## 174-17-CA

709 HINSDALE STREET  
GLENWOOD-BROOKLYN  
HISTORIC DISTRICT (R-10)

APPLICATION FOR A CERTIFICATE OF APPROPRIATENESS – STAFF REPORT

# PROPOSED PLOT PLAN

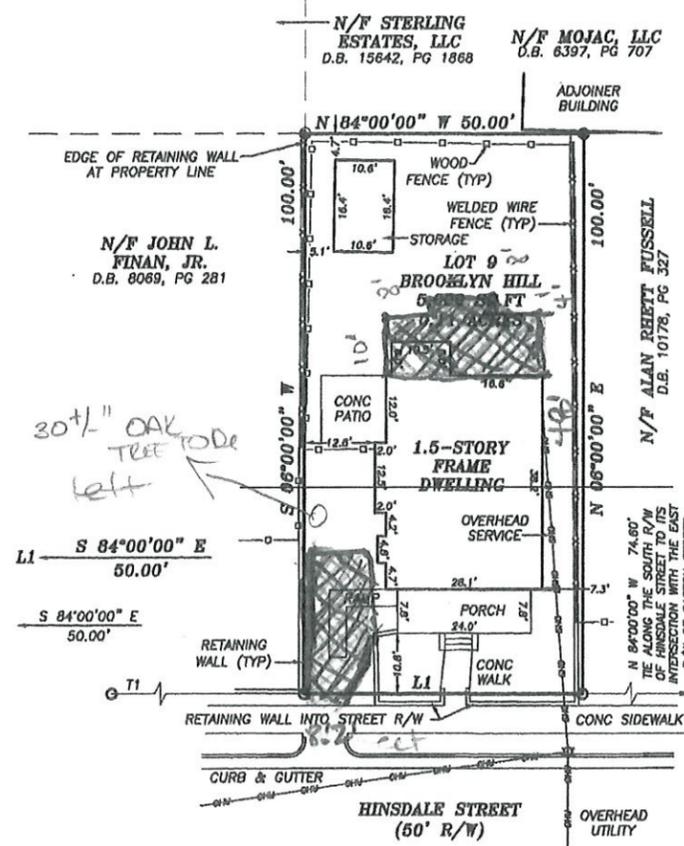
- 2\* A wood ramp will be removed from the left side of the porch under the previously issued COA 183-17-MW.
  - 3\* The plot plan shows a 30" oak on the property line near the end of the driveway. In a Streetside HOD landscape elements are only regulated from the front wall of the house to the street, therefore no tree protection plan is required.

- 4\* The application did not include a detailed site plan with the design and dimensions for the driveway, nor a description of materials.
- B. Replacing the light fixture and installing a ceiling fan on the front porch is not incongruous in concept according to *Guidelines* 1.7.1, 1.7.2, 1.7.3, 1.7.9, 1.7.10, and the following suggested facts:

- Scaled drawings of an existing site plan and a detailed proposed site plan, each on an 11"x17" page, that includes the right-of-way, trees in the regulated areas (on site and cross boundary), planting areas, driveway, sidewalks, and any other relevant features. The site plan should indicate the location of the front wall of the house to clarify the regulated area of the yard (this may be shown as a line extended the width of the property). The site plan should also indicate the 50% line of the house indicating regulatory review of changes to the original structure.

# PROPOSED LEFT ELEVATION

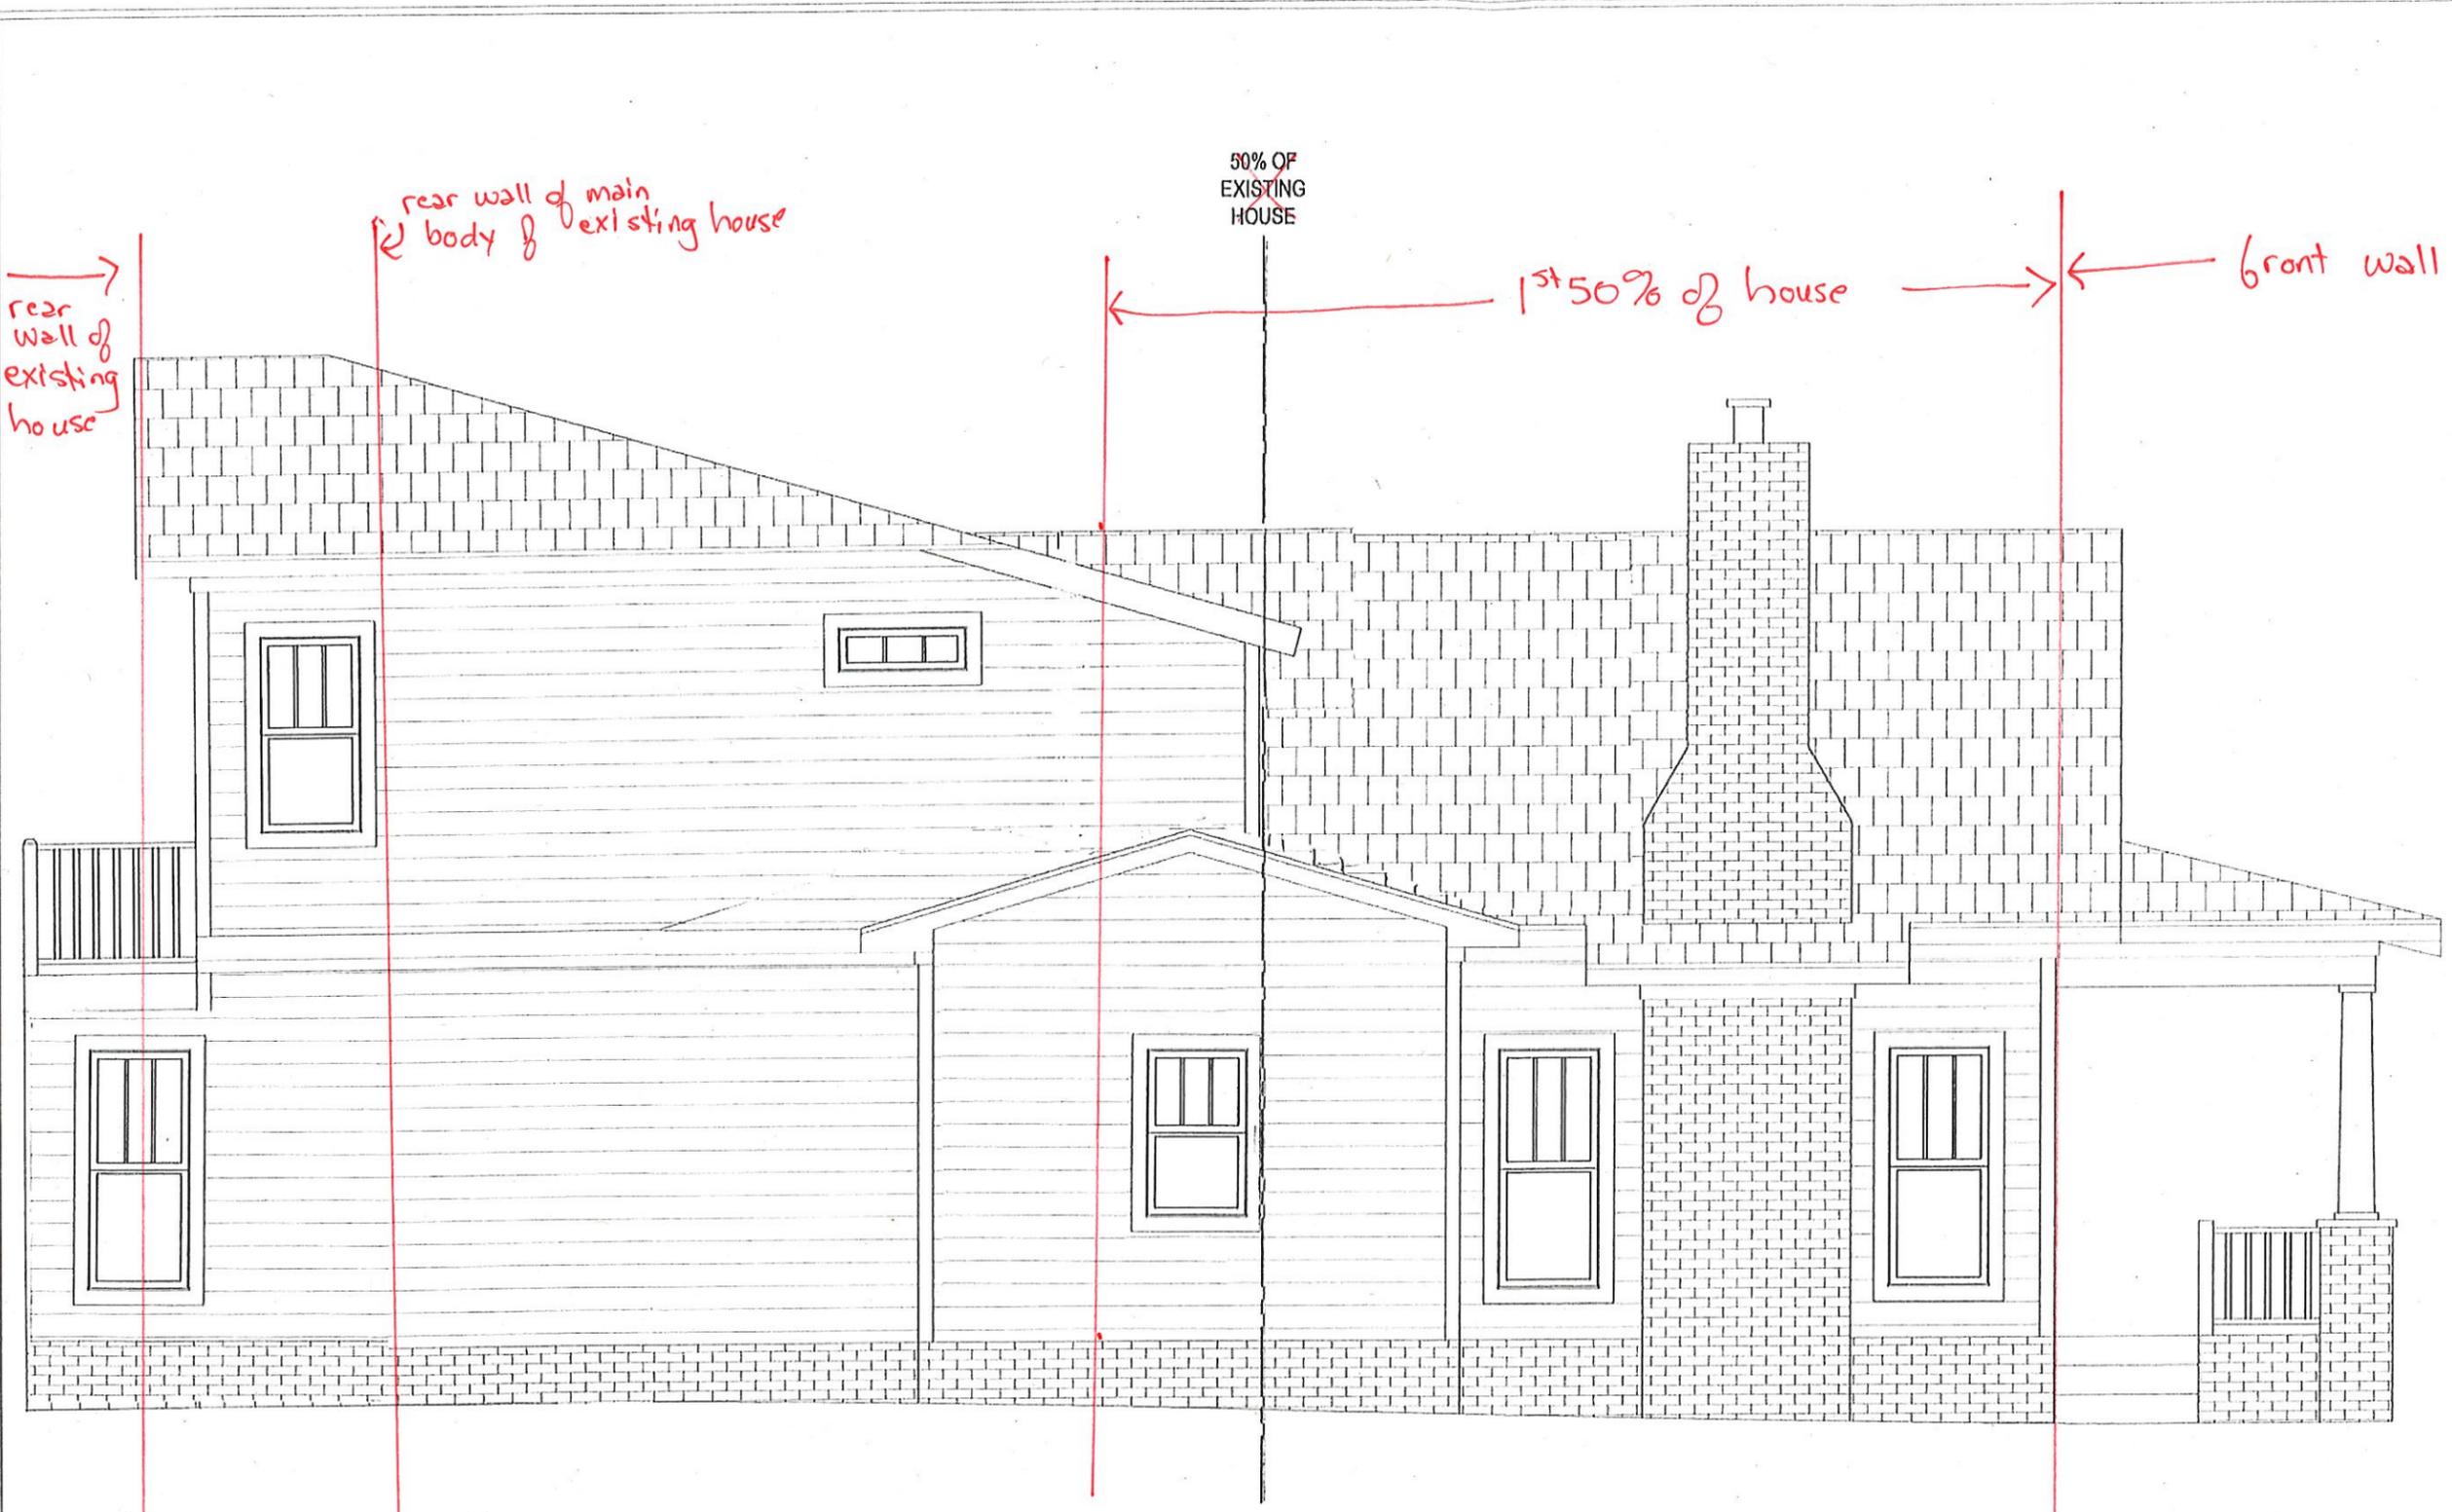
4\* The elevation drawing shows the roof of the gable end east side historic addition has been altered to a lower pitch from what it is currently.

- 1\* On the drawings provided in the applications, the measurement showing the 50% line for review of changes on the house is inaccurate. The 50% line is further towards the rear of the house than is shown. Staff evidence has been provided to illustrate this.

- 4\* Window changes show alterations to both sides of the house within the first 50%:
  - a. Replacing paired windows on the left (east) side with a single window of different proportions;

**PROPOSED RIGHT ELEVATION**

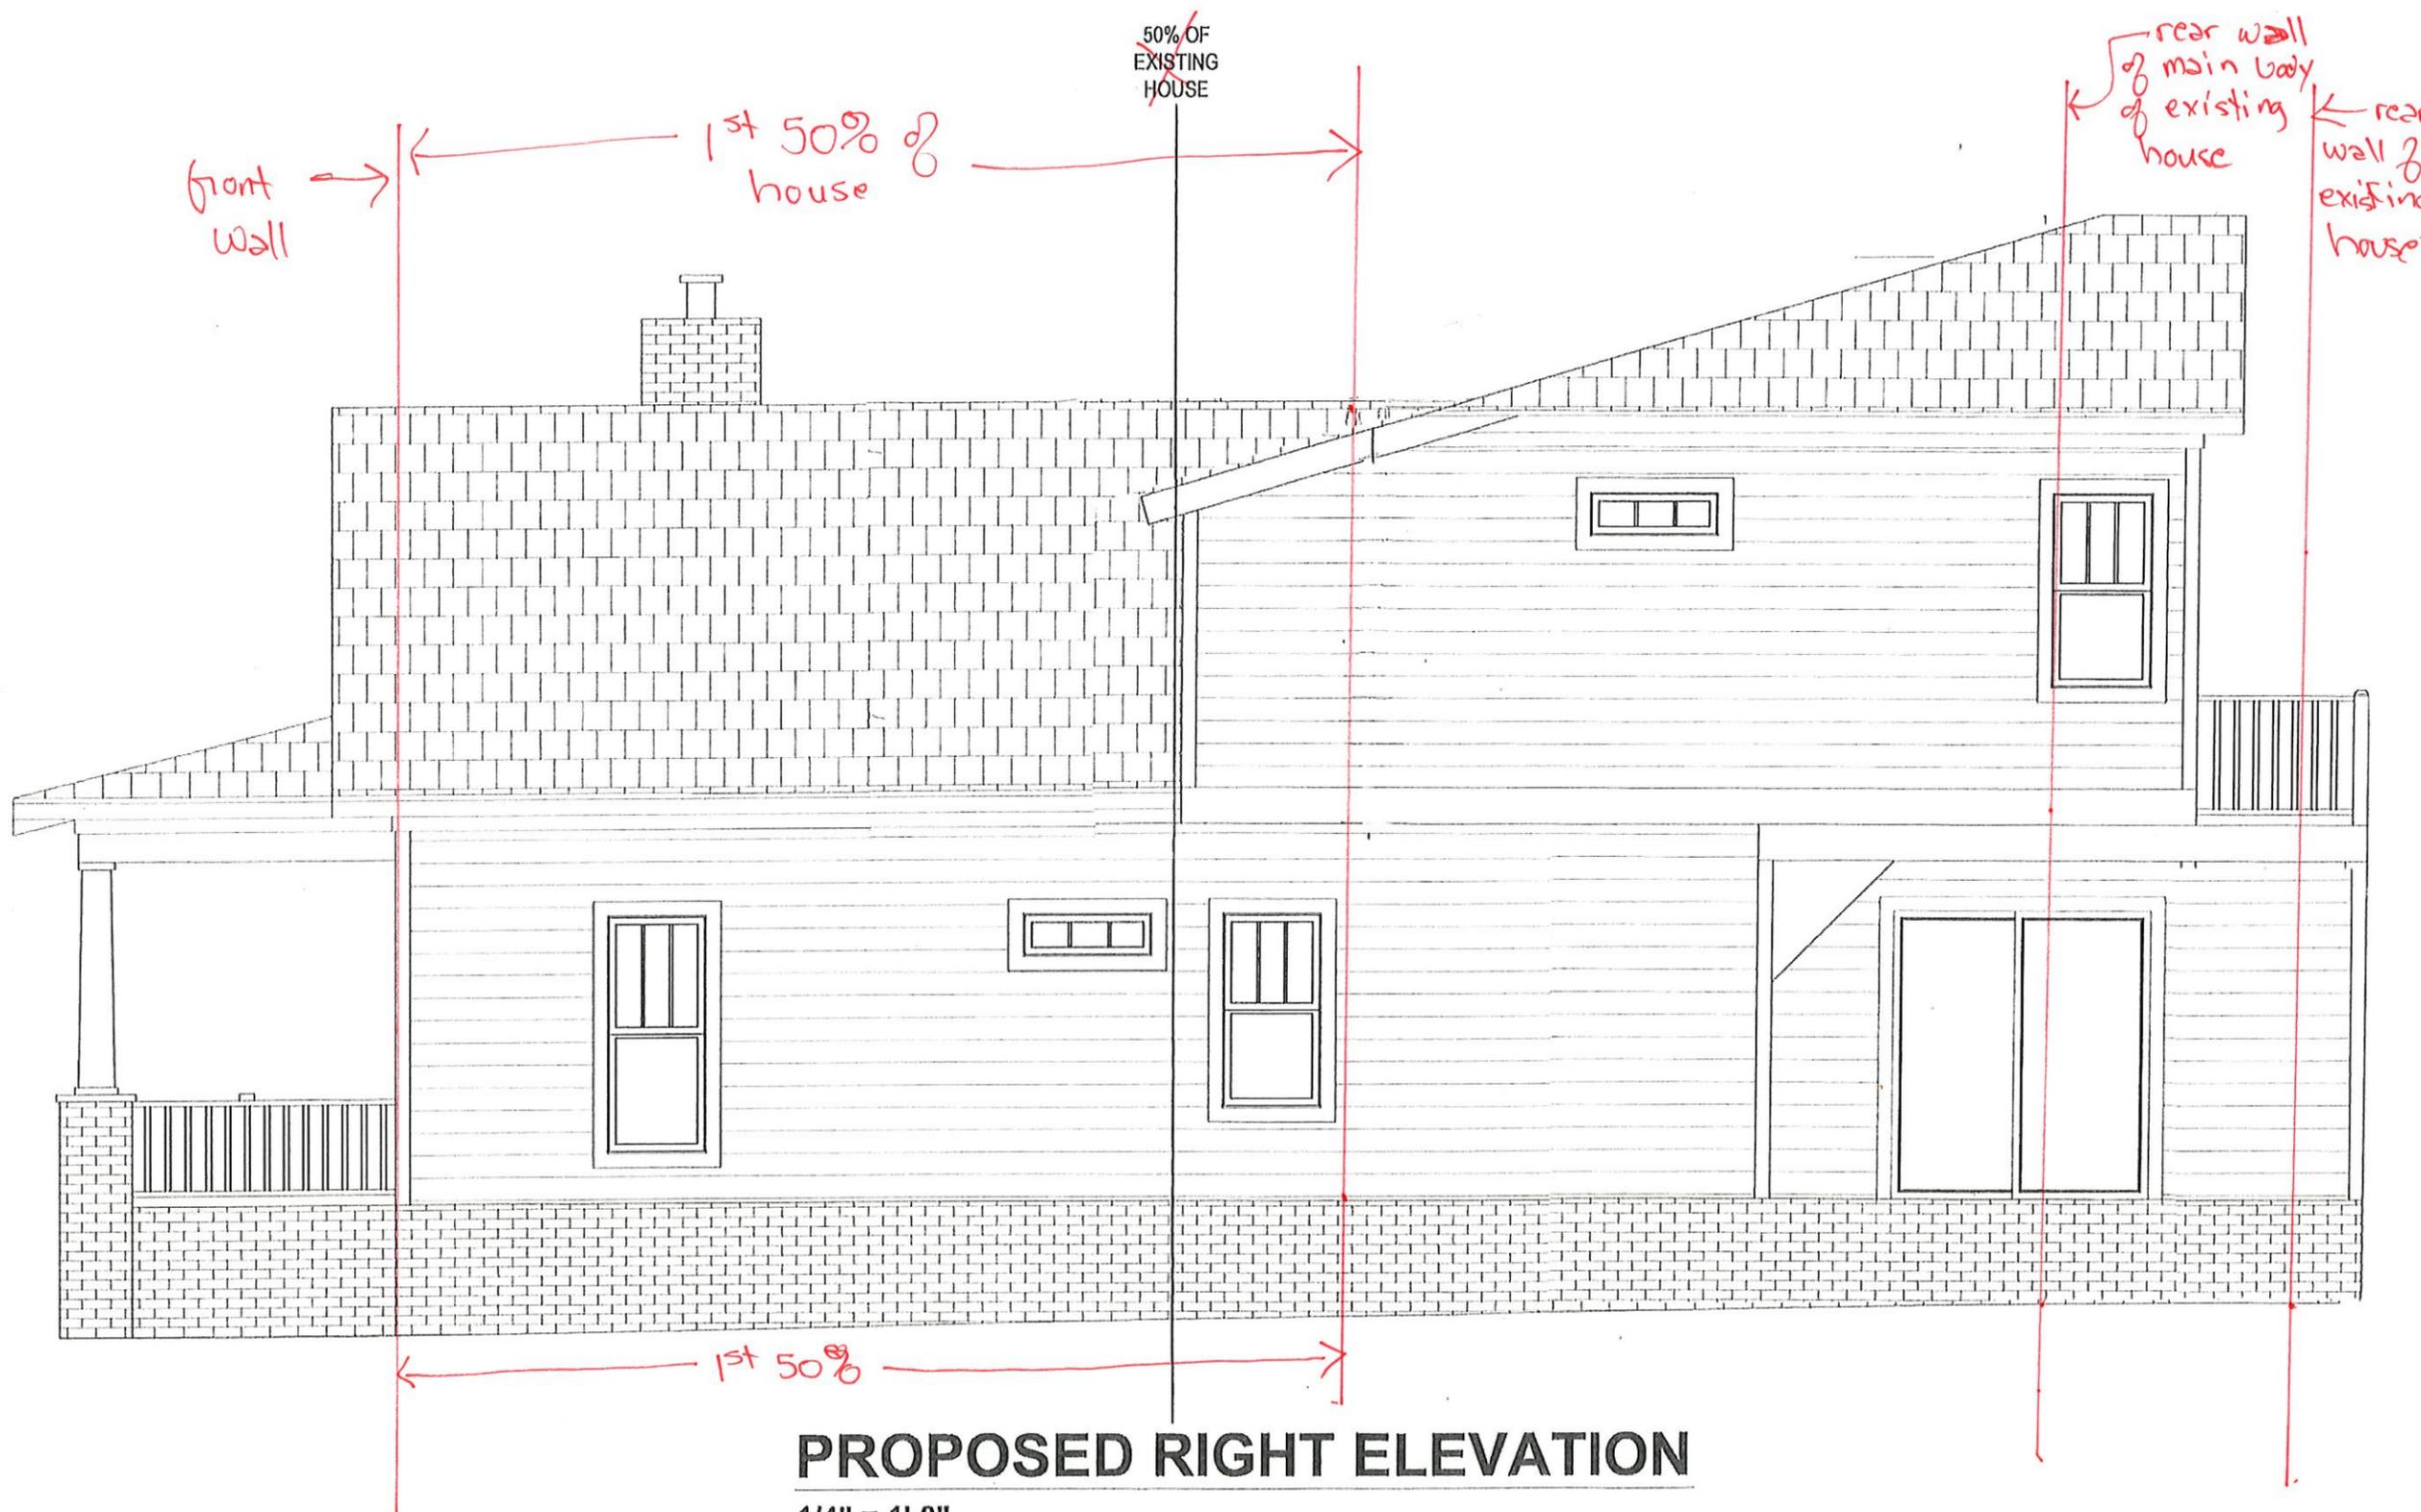
- b. replacing paired windows on the right (west) side with a single window of different proportions;
  - c. installing a new horizontal window for a bathroom on the right (west) side. This window form is atypical in the historic district.

- 10\* Windows on the addition are of a variety of sizes and proportions including the following:
  - a. The proposed horizontal windows on the second level of the addition (both left and right sides) are atypical in historic districts;
